**Light vehicles – Global Technical****Regulation No. 15 on Worldwide harmonized****Light vehicles Test Procedure (WLTP)****Proposal for Amendment 2 to global technical regulation  
No. 15 (Worldwide harmonized Light vehicles Test  
Procedures (WLTP))****Submitted by the Informal Working Group on Worldwide harmonized  
Light vehicles Test Procedure (WLTP)\***

The text reproduced below was prepared by the Informal Working Group (IWG) on Worldwide harmonized Light vehicles Test Procedure (WLTP) in line with Phase 2 of its mandate (ECE/TRANS/WP.29/AC.3/44). The modifications to the current text of global technical regulation No. 15 are marked in track changes.

# Global technical regulation on Worldwide harmonized Light vehicles Test Procedures (WLTP)

Figure A6/2  
Speed trace tolerances

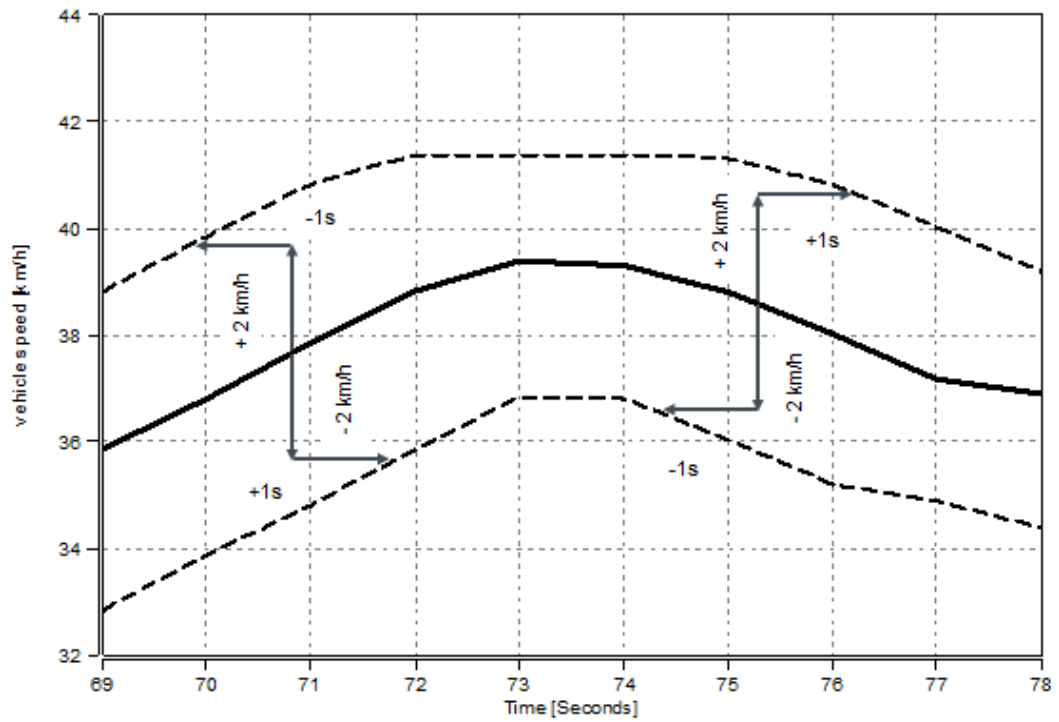
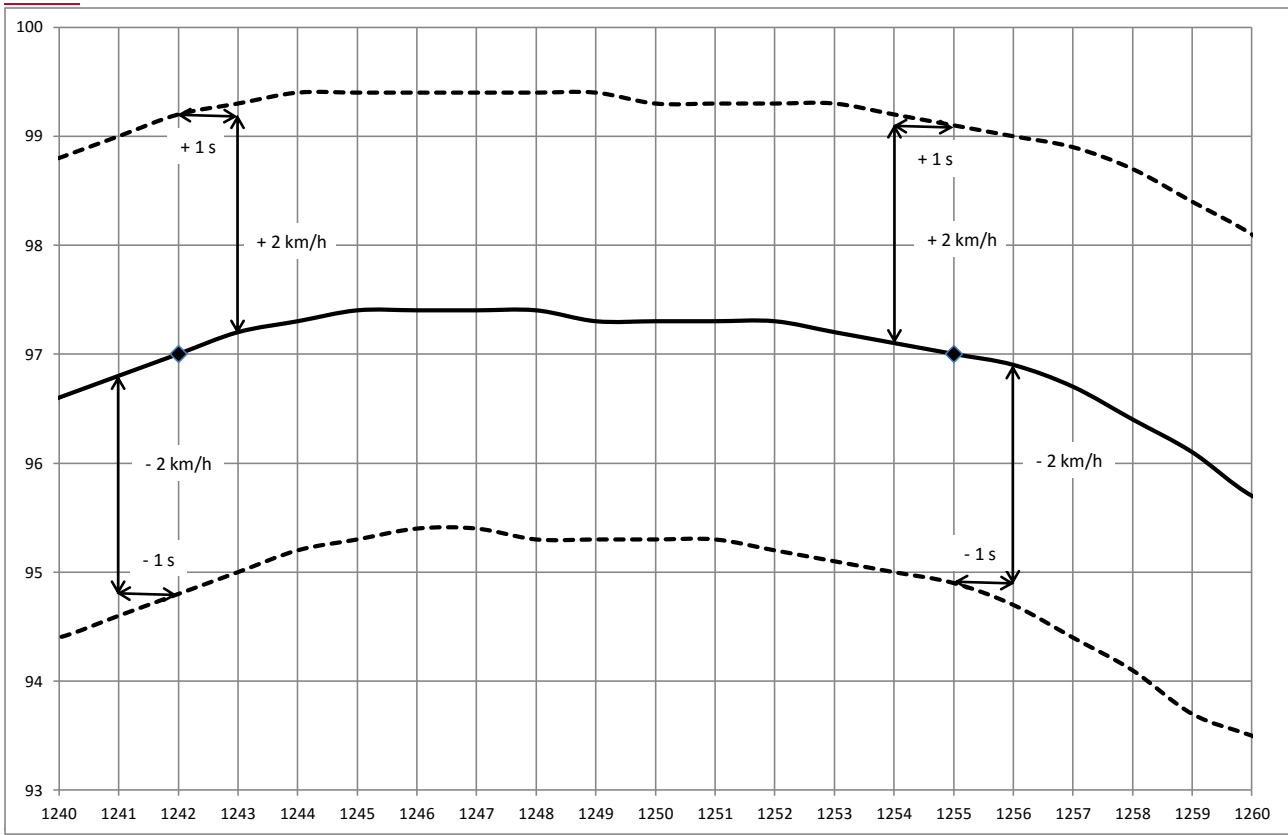
~~See Figure A6/2.~~

~~There shall be no more than ten such deviations per test.~~
